### Development Application -Redevelopment of Macquarie House

# M A C Q U A R I E H O U S E D E V E L O P M E N T

CIVIC SQUARE, LAUNCESTON, TASMANIA

### **DA0440/2016 - Request for Further Information**

SK 02 SITE & LANDSCAPE PLAN  
 1:200  
 KK, NH

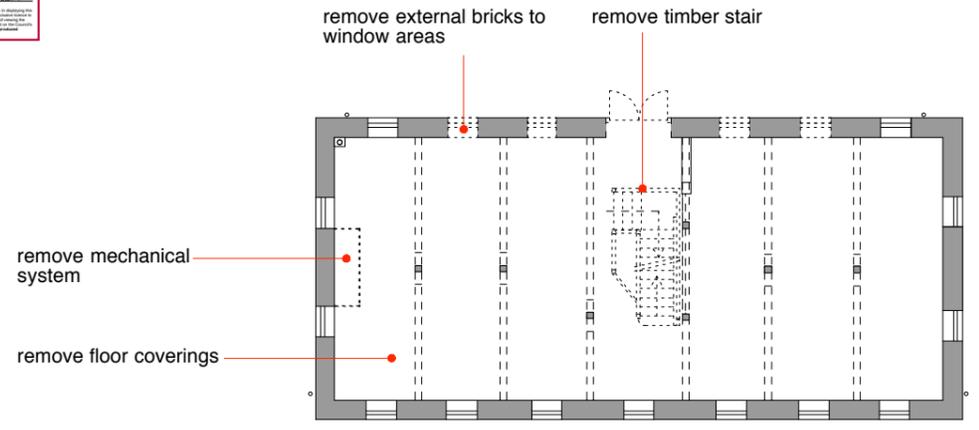
### **Item 03 - Tree Removal**

Amended drawing *Macquarie House DA-SK-02-Rev-02* included with this correspondence has been updated to show both trees proposed for removal.

remove leaning pine tree

remove tree
